RANCHO MURIETA COMMUNITY SERVICES DISTRICT

IMPROVEMENTS COMMITTEE

Special Meeting
September 18, 2024 at 8:00 a.m.

Subject: Submittal Response

ASC Project # B22360	Date 07.20.2023
Drawn By N. ROTAS	Sheet 2
Checked By T. PINION	E1.0
Scale NONE

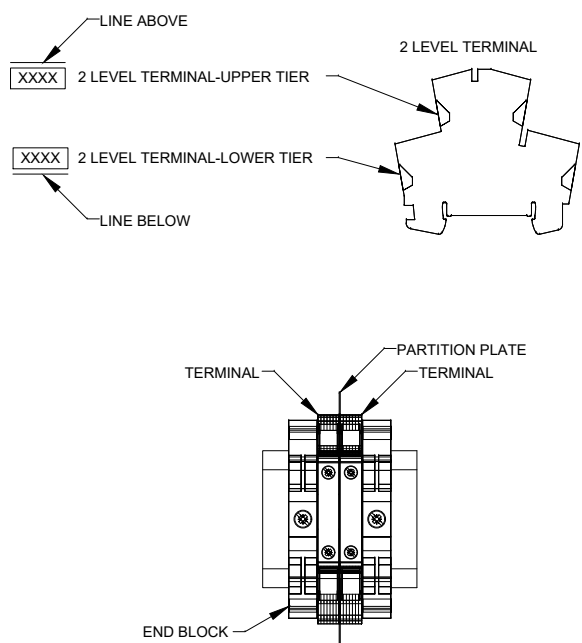
1). E1.0 The wire color code still does not match as well as has conflicts with the newer tesco version I sent with the newest tesco drawings for the back pan replacement project.

The wire color is fixed according to match TESCO Wire Color Legend template.

ASC Project # B22360	Date 07.20.2023
Drawn By N. ROTAS	Sheet 3
Checked By T. PINION	E2.0
Scale NONE

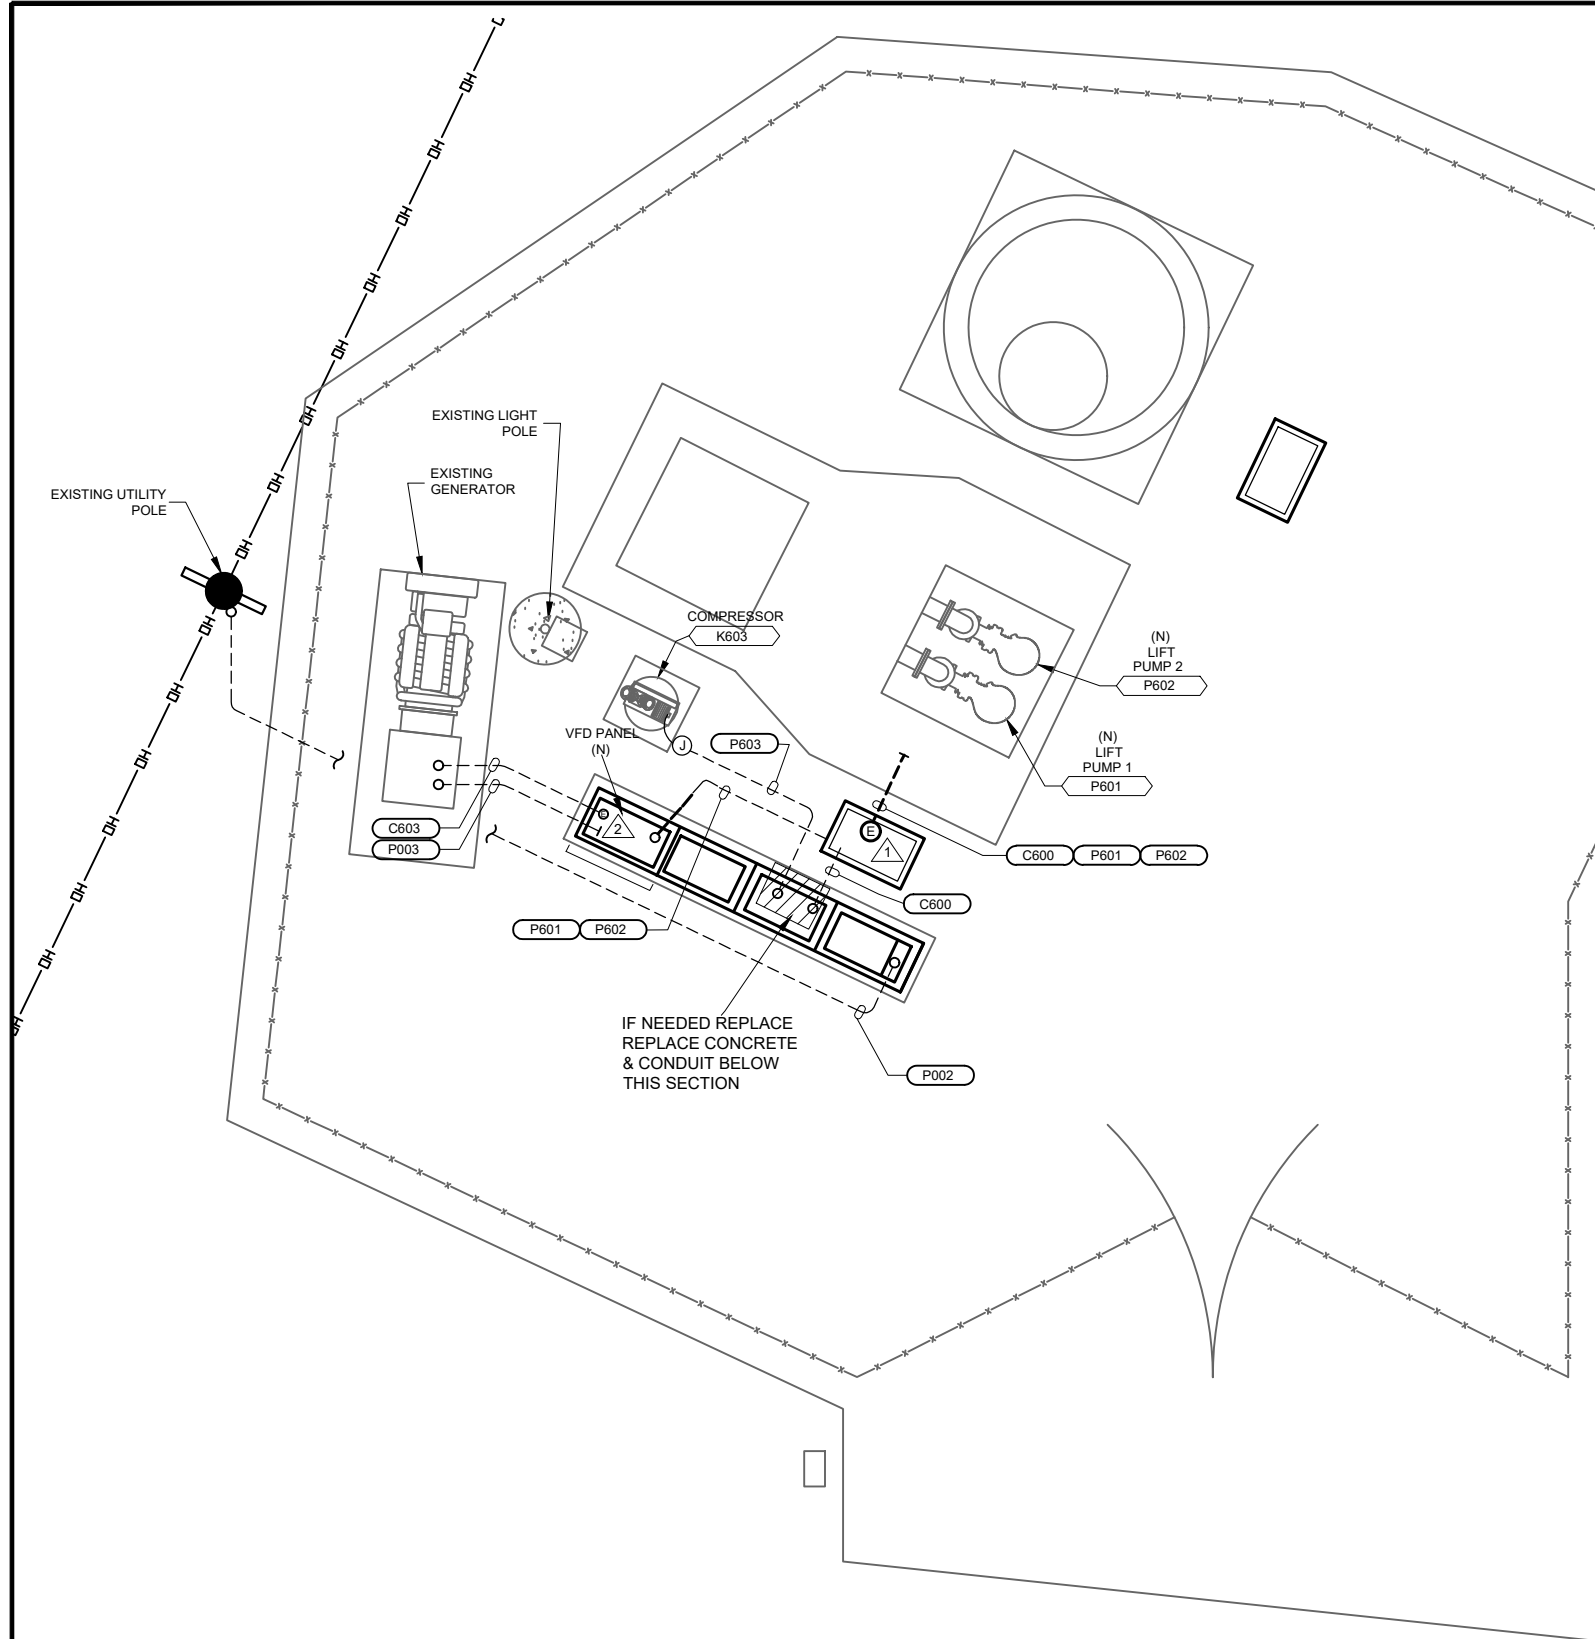
2). E2.0 Does not show the $\frac{3}{4}$ " control conduit going to the generator which will need to be intercepted for panel placement.

7). E9.0 i) Note that the generator also has a 3/4" control pipe that both generator pipes need to be intercepted for the panels being put together.

This pipe will need to be intercepted for the panel to be installed. It may not need to be changed but it should be noted.

Drawing E2.0, and E9.0 fixed. The existing conduit is named C603.

Drawing E2.0, and E9.0 fixed. The existing conduit is named C603.

ASC Project # B22360	Date 07.20.2023
Drawn By N. ROTAS	Sheet 4
Checked By T. PINION	E3.0
Scale NONE

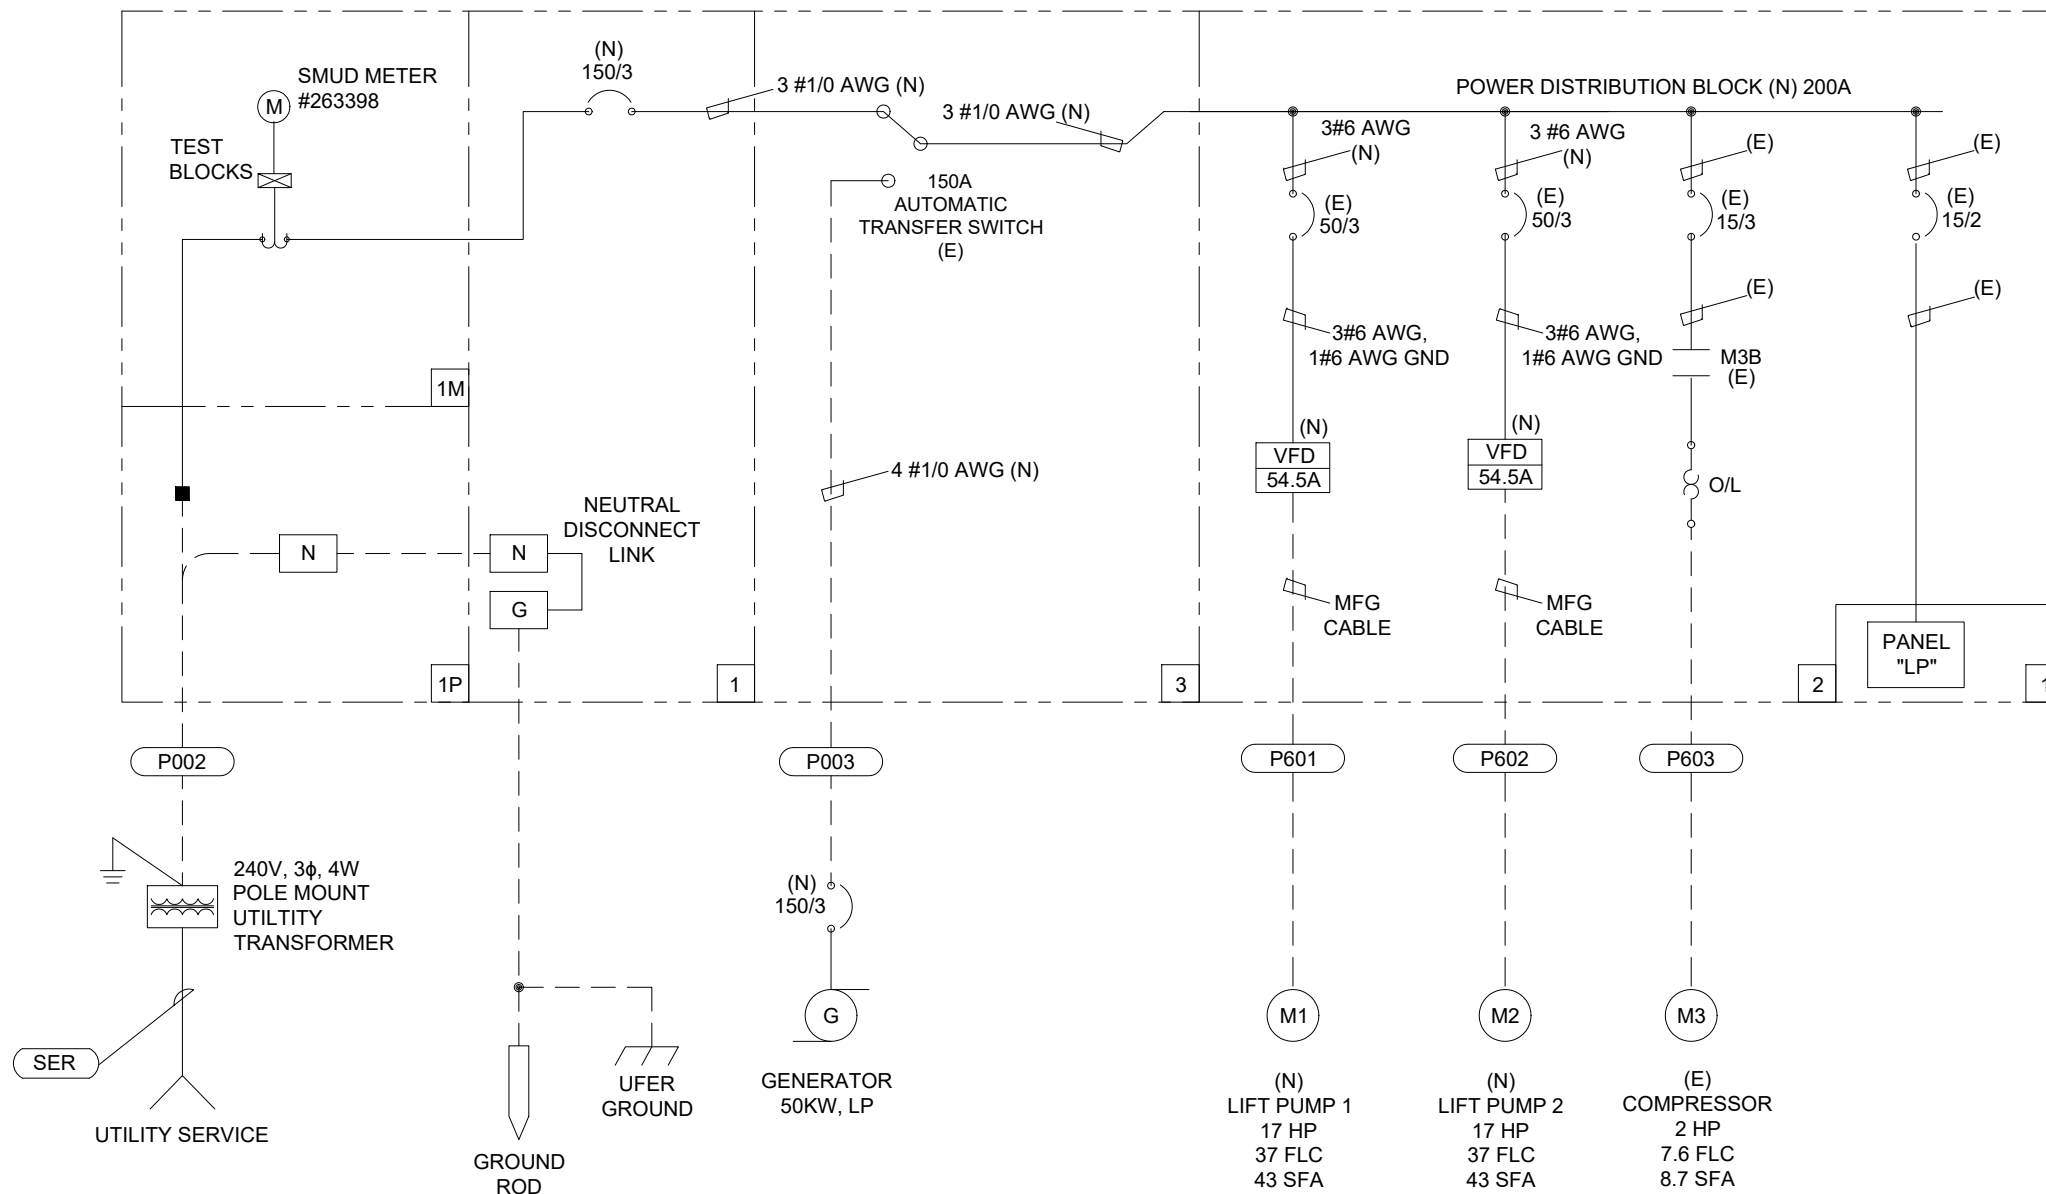
3). E3.0 Single line diagram should show all the proper wire sizes for every transition. Use nec conductor sizing table for proper sizes using 60 deg Celsius. That way we are clear on all the wires that are being replaced and what sizes they will be.

if it is not show in the drawings we will need to inspect before being put into service to verify proper sizing.

We added the wire sizes on single line diagram.

ASC Project # B22360	Date 07.20.2023
Drawn By N. ROTAS	Sheet 6
Checked By T. PINION	E5.0
Scale NONE

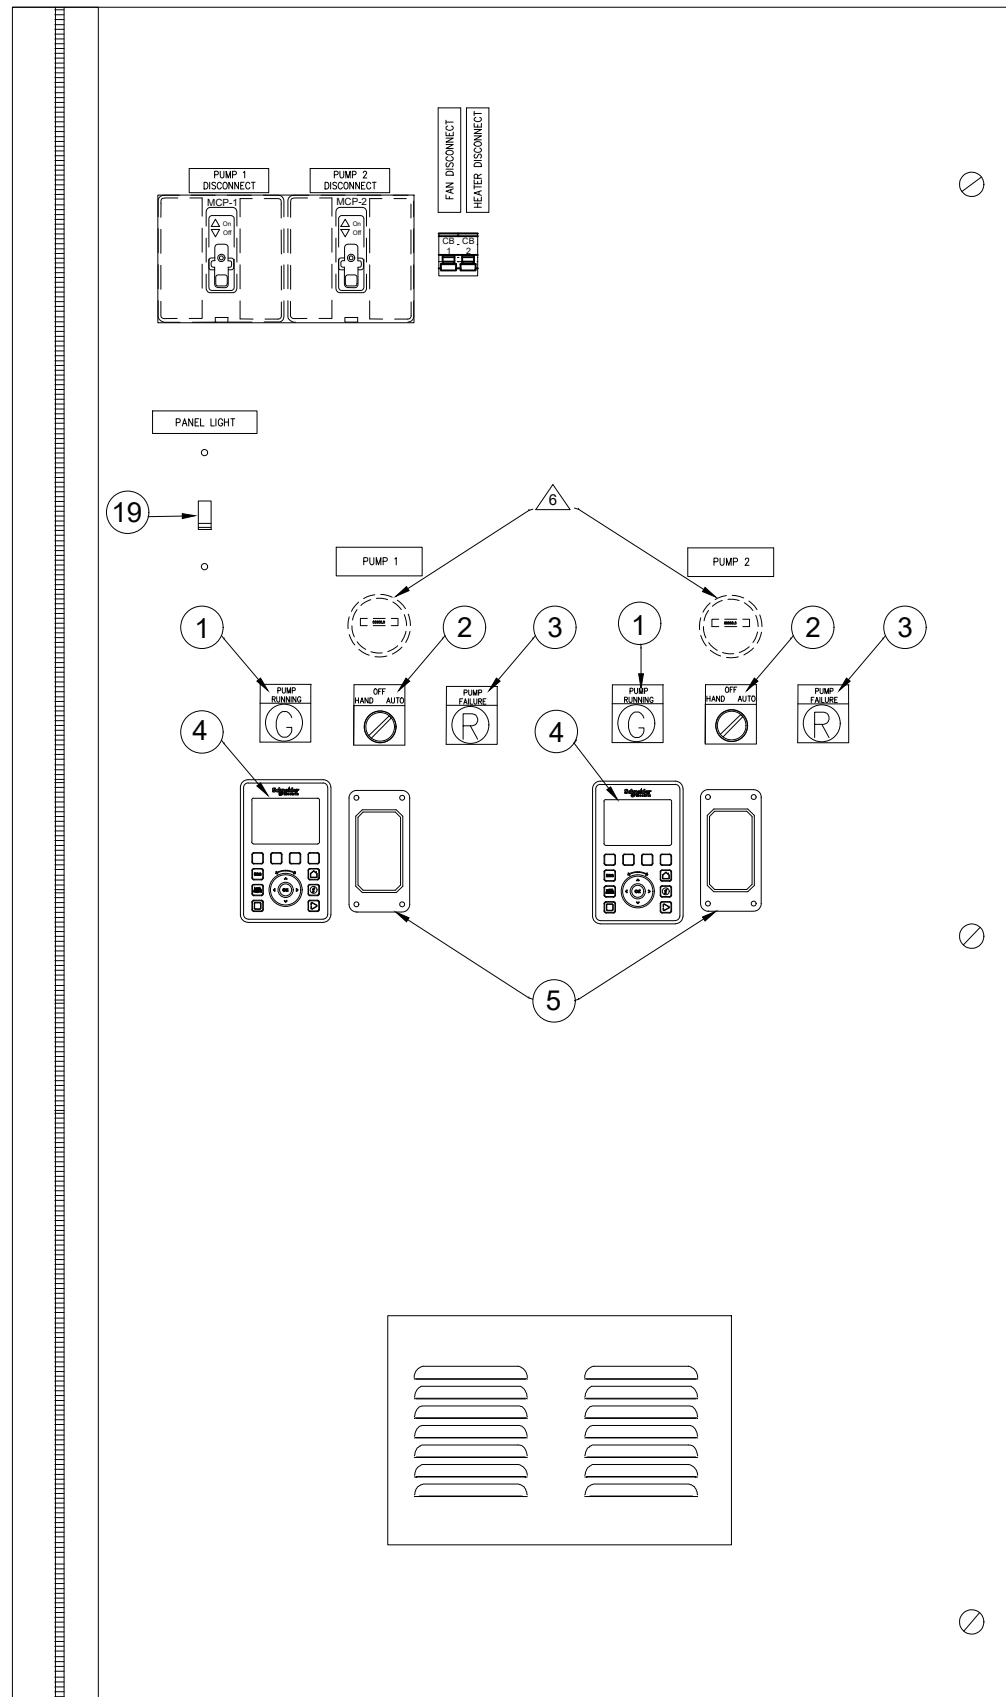
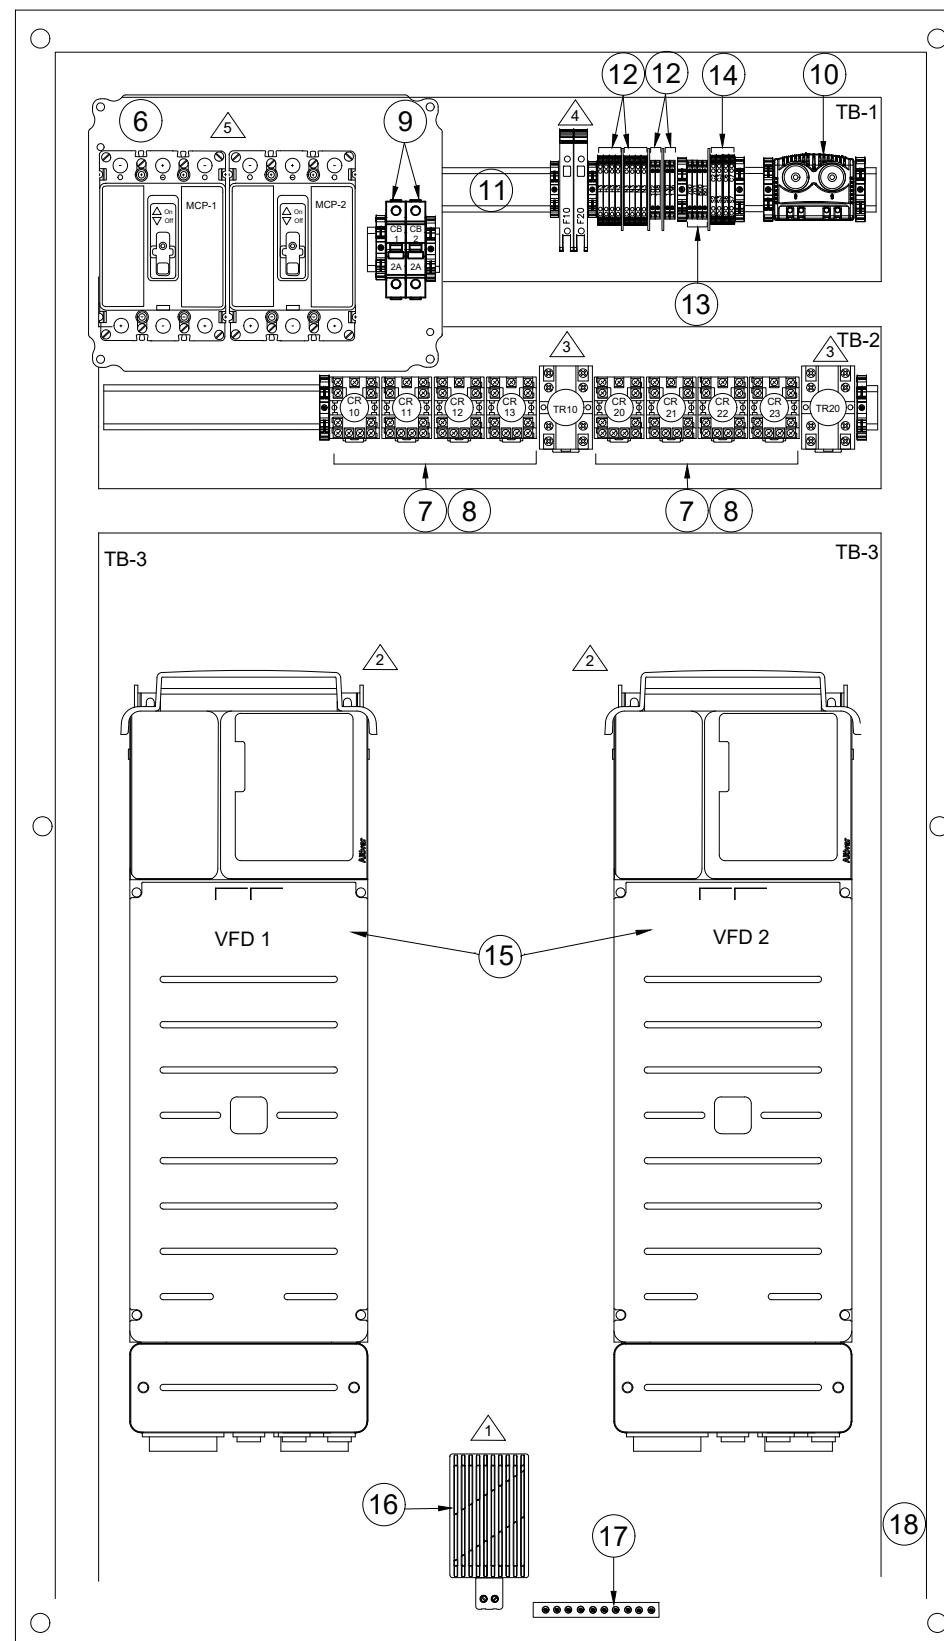
4). E5.0 Relays should be Idec rr3b ul 120ac, timers should be rte-p1af20. As the district has many sites with these already installed keeps the parts necessary to keep on hand to a minimum.

Drawing E5.0 and BOM changed. The relays replaced with the IDEC RR3B-ULAC120V. About the time relays, we will use the existing materials. See drawing E5.0, note 3 about time relays.
